APPLICATION NO.	FILING DATE	FIRST NAMED INVENTOR	ATTORNEY DOCKET NO.	CONFIRMATION NO.
10/723,154	11/24/2003	Bernard Favre-Bulle	DT-6685	9264

Office Action Summary

DETAILED ACTION

U-2752,814 to IAIA

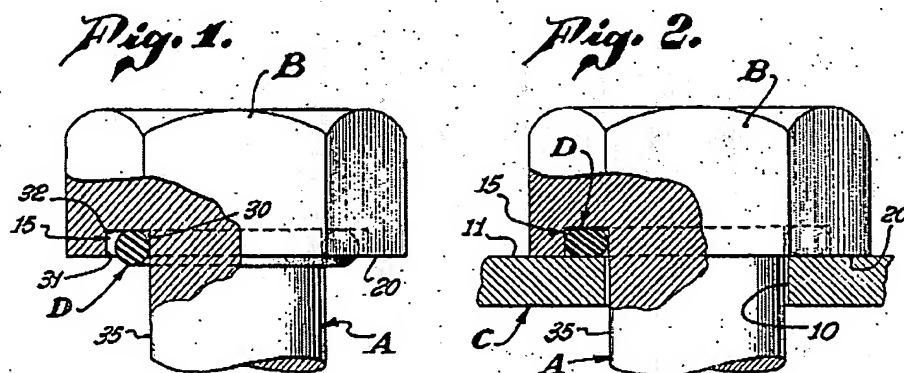
US-2,752,814 to IAIA and US-3,746,348 to Stone teach that is well-known to design a circular recess to have a diameter slightly larger than an energy dissipation element to allow

room for outward deformation. The energy dissipation element is further designed to *"project[ing] beyond the free flat end surface"*.
